ADDENDUM 2

SUBJECT: SAPD Academy Track Pavement, (ID No.: 23-04058), Date of Issue: Friday, August 1, 2025, Scheduled to Close: Tuesday, September 16, 2025

THIS NOTICE SHALL SERVE AS ADDENDUM NO. 2 – TO THE ABOVE REFERENCED INVITATION FOR BIDS

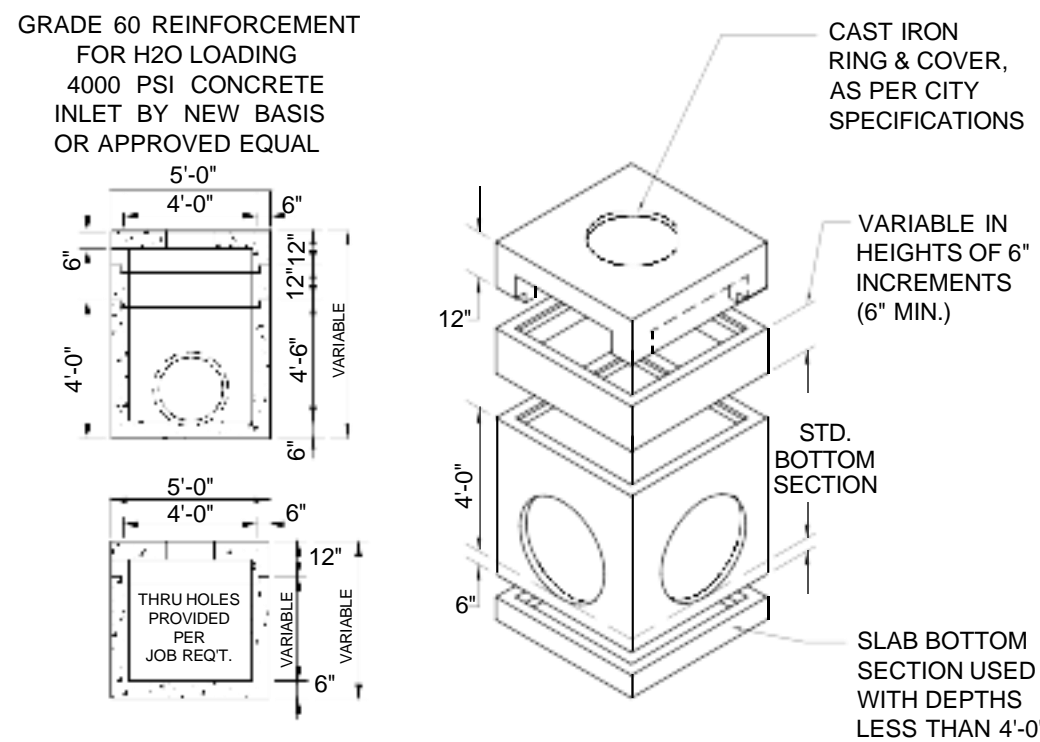
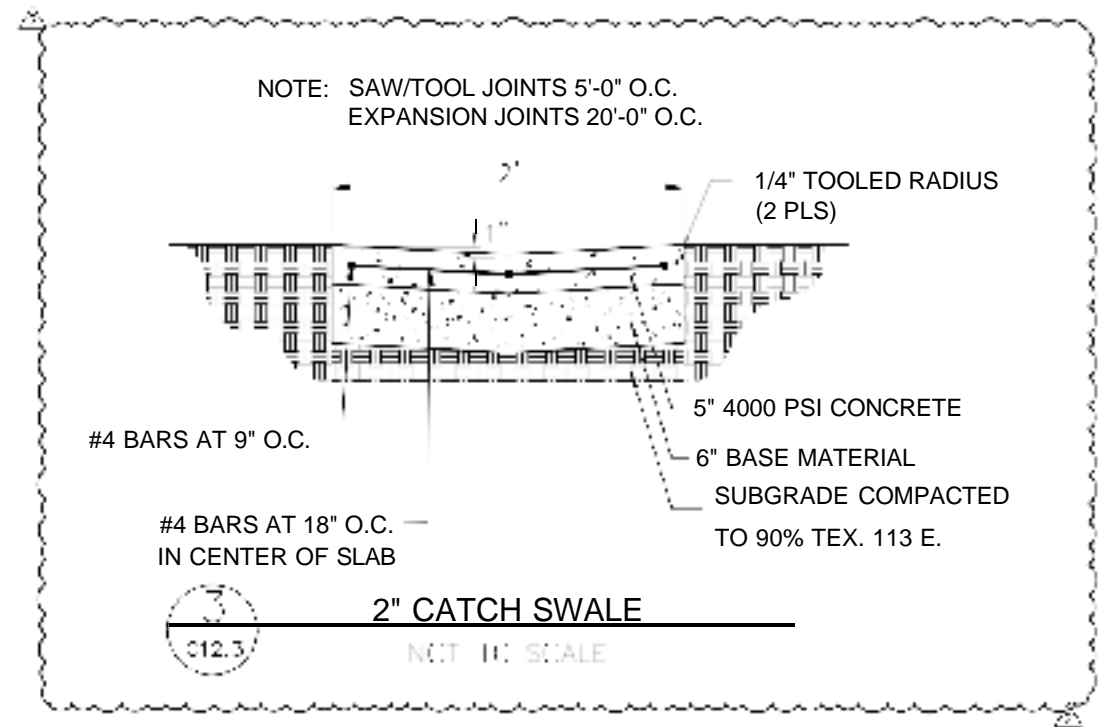
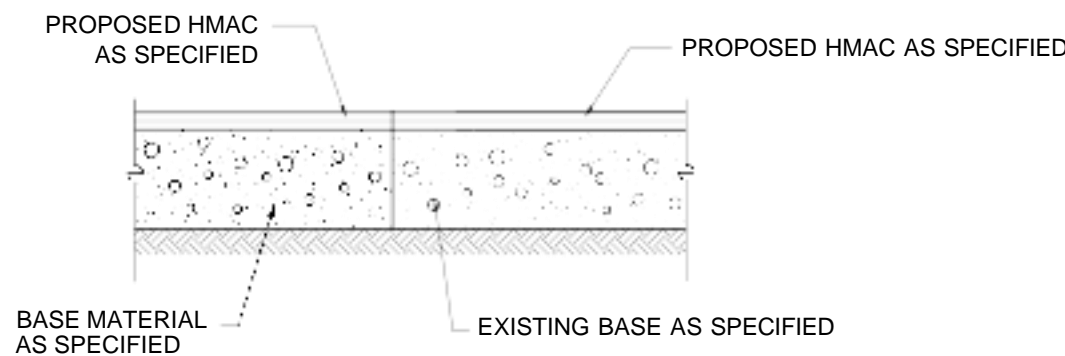
Question 30: What is the spec thickness of sand cushion below 2' catch swale.

C12.3 - Pavement Details - Revised concrete swale detail.

Response: The swale detail has been revised for clarity. See sheet C12.3.
